Access Compliance Report

Public Rights-of-Way

Intersection ID: 10036687	Main Street: S_CHURCH_ST	Cross Street: N/A	Location: NW
ADA ID: CC44BF2FC53C	Ramp Type: Perp	Initial Pass/Fail: Fail	Overall Compliance: No
		Severity Score: 12.5

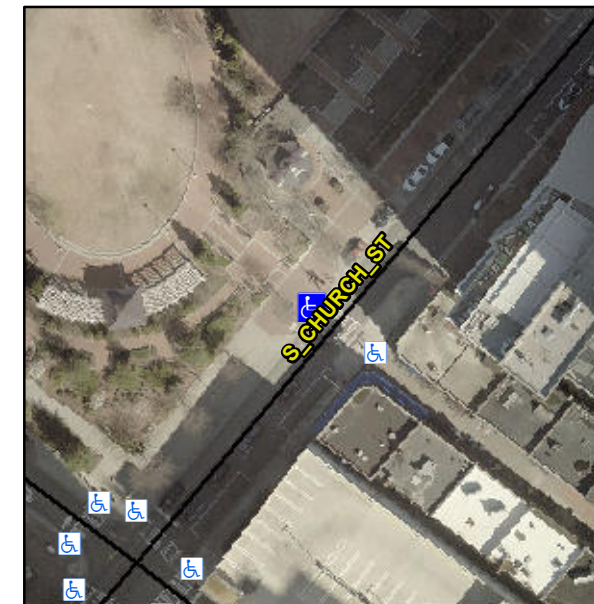
Not Found, R304.5.3

Compliance	Description	Data	Compliance	Description	Data
N/A	Ramp Length (in)	71.0	Yes	Ramp Slope (%)	8.0
Yes	Ramp Width (in)	72.0	No	Ramp XSlope (%)	6.0
N/A	Flare Type LT	N/A	N/A	Flare Type RT	N/A
N/A	Flare Slope LT (%)	N/A	N/A	Flare Slope RT (%)	N/A
N/A	Flare Traversable LT?	N/A	N/A	Flare Traversable RT?	N/A
N/A	Landing Length (in)	N/A	N/A	DWS Provided?	N/A
N/A	Landing Width (in)	N/A	N/A	DWS Contrast?	N/A
N/A	Landing Slope (%)	N/A	N/A	DWS Length (in)	N/A
N/A	Landing X Slope (%)	N/A	N/A	DWS Full Width?	N/A
N/A	Landing Curb? (Y/N)	N/A	N/A	DWS Offset (in)	N/A
N/A	Shared Landing?	N/A			
N/A	Gutter Ponding?	N/A	N/A	Gutter Slope (%)	N/A
N/A	Gutter Lip Ht (in)	N/A	N/A	Gutter X Slope (%)	N/A
N/A	Painted X Walk1?	Yes	N/A	Painted X Walk2?	N/A
	X Walk 1 Direction	To SE		X Walk 2 Direction	N/A
N/A	X Walk 1 Width (in)	171.0	N/A	X Walk 2 Width (in)	N/A
	X Walk 1 Slope (%)	7.4		X Walk 2 Slope (%)	N/A
	X Walk 1 X Slope (%)	1.3		X Walk 2 X Slope (%)	N/A

Remove & Replace Entire Ramp.
